From: John Ke
To: Kuhn, Julia, ENV
Cc: Rob Liles
Subject: [EXTERNAL] YGI Response to 10/30/26 Meeting with NMED
Date: Monday, November 2, 2026 12:12:46 PM
Attachments: image001.png

RE: Response to 10/30/26 Meeting with NMED (Agency Interest No. 41351 – PRN20260001) – YGI Microgrid

The following provides Yucca Growth Infrastructure, LLC's (YGI) responses to questions raised in the 10/30/26 Meeting with the New Mexico Environment Department (NMED).

Figure 1. Side View of Platform Layout

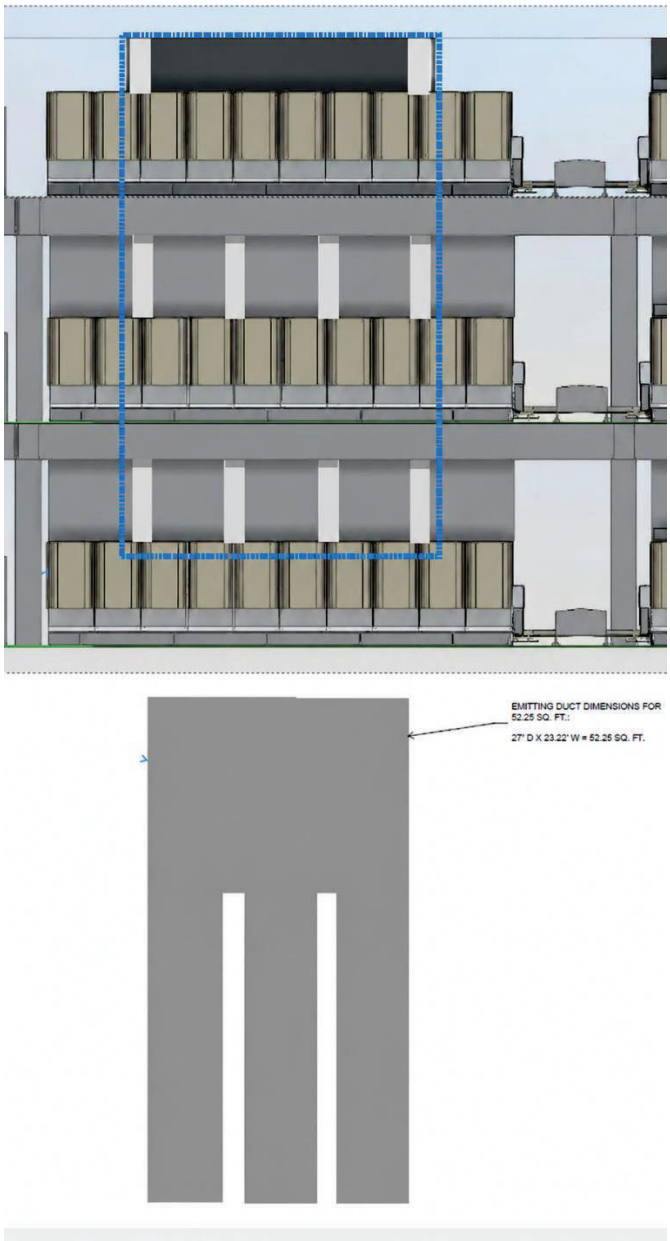
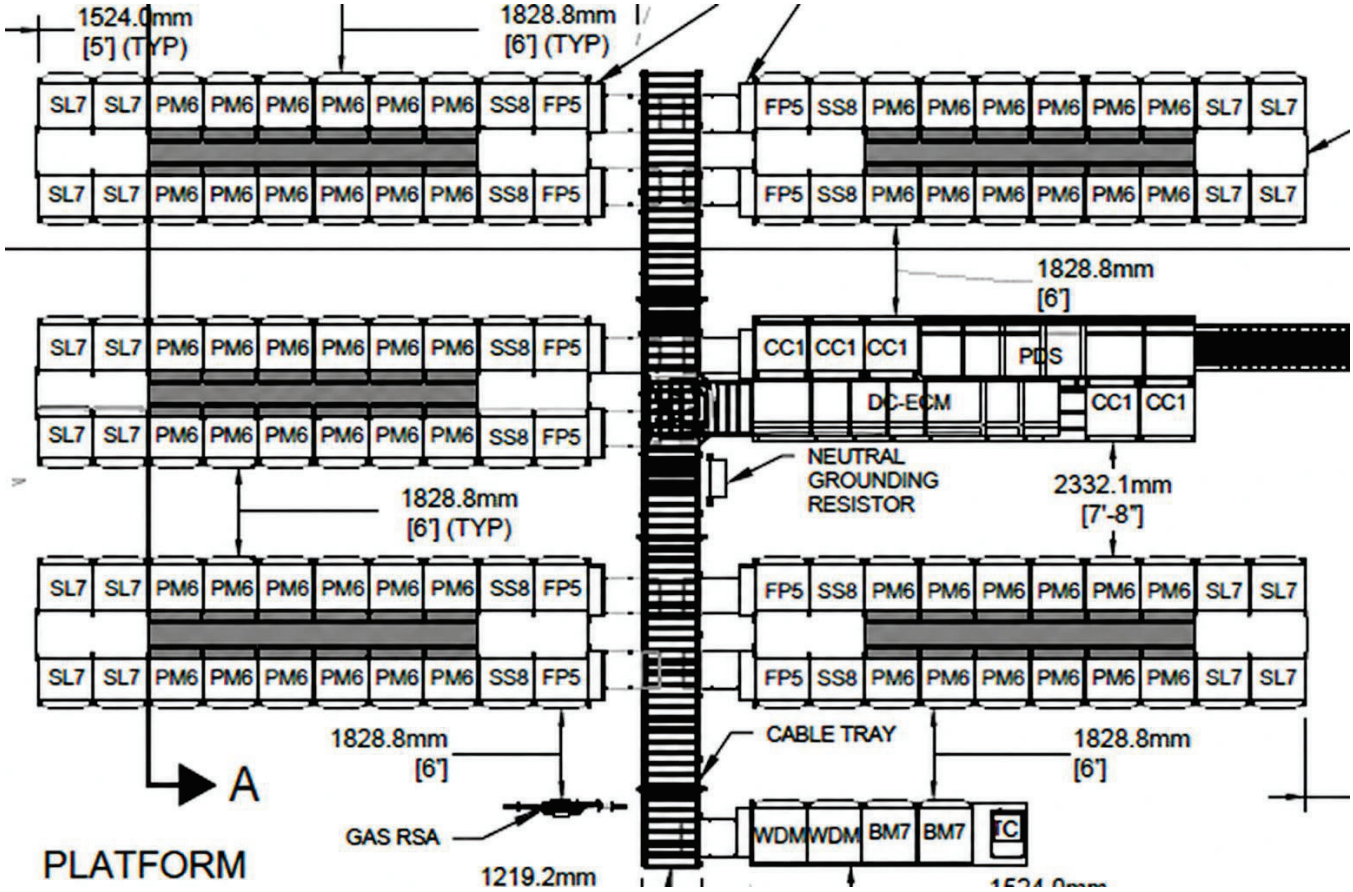
3. How are structures set up in AERMOD to accurately model building downwash?

BPIP-PRIME downwash structure inputs represent the physical dimensions of the solid structures that disturb airflow. The structural design of the facility is set up as a three-tier platforms with power modules and other ancillary equipment on each level. These structures are open to the air, and air can freely move through all tiers. Because the plenums that vent emissions from the power modules extend from floor to ceiling in the first two tiers, YGI conservatively modeled the structure as a solid in AERMOD up to the height of the third platform. The designed height of the tallest platform on the three-tier Energy Server structure is 32 ft and the 45 ft proposed release height of the stack is the discharge elevation of the exhaust duct (stack). It rises above the structure and is not part of the structure. Under EPA's Good Engineering Practices (GEP) stack-height guidance and BPIP-PRIME practice, a stack is not treated as a structure for downwash, and structure heights are not typically raised to match stack heights. In addition, AERMOD's regulatory-default stack-tip downwash algorithm accounts for the wake created by the exhaust outlet itself, using the full 52.25 ft^2 discharge area (8.16-ft equivalent diameter). When wind speeds are high relative to the exit velocity, this lowers the effective release height below the 45-ft stack height, so the model does not take full credit for the stack's height above the structure.

YGI contends for the reasons stated above that the methodology for evaluating downwash in the prior model submittals (a methodology that has not changed since the original April submission) was appropriate. However, in order to address questions from NMED regarding downwash, YGI has run scenarios that reflect a downwash structure assumption that YGI expects to resolves the NMED's question. Specifically, to account for the fact that the proposed Type A stacks are rectangular plenums that extend 13 ft above the final platform, and the highest tier of platform will also contain power and ancillary modules that are up to 7 ft tall, as shown in Figure 1, YGI has conservatively set the structure height at 39 ft (32 ft tall platform + 7 ft tall energy servers).

This does not represent a change in the structural change in the design for the model that was submitted to NMED on 10/15/26, but rather, this is representing the structures in AERMOD in a more conservative way with respect to building downwash. This is reflected in the BPIP file submitted in conjunction with this response. Within each individual structure, there are also five plenums, modeled as 45 feet tall "walls", which are 23.22 ft. by 2.25 ft, as shown in Figure 2. Each stack is centered on these walls. This is for all the platforms that hold the Type A stacks. There is one structure that holds the singular Type R stack. For that structure, the height of the structure was conservatively set at the height of the stack and the plenum is not modeled as a wall, as the Type R exhaust is at the height of the energy server.

Separately, the gap between these platforms in a north-south direction is spanned by grating. The buildings are not one entire solid structure north to south, and air can flow through the space in between each platform. Notably, the BPIP algorithm will already combine the buildings that are in the area of influence of each stack due to their relative proximity to each other. As such, to conservatively model downwash, YGI combined the platforms together in AERMOD and set it up in the model as one entire structure for each column of nine or ten platforms, leading to 27 structures representing these platforms in the model; this is also reflected in the BPIP files that are attached to this response. This is not a change in the structural design for the 10/15/26 model, but rather updating the structure in AERMOD to be more conservative with respect to building downwash. Results comparing this sensitivity analysis to the October modeling are included below in Tables 1 and 2.
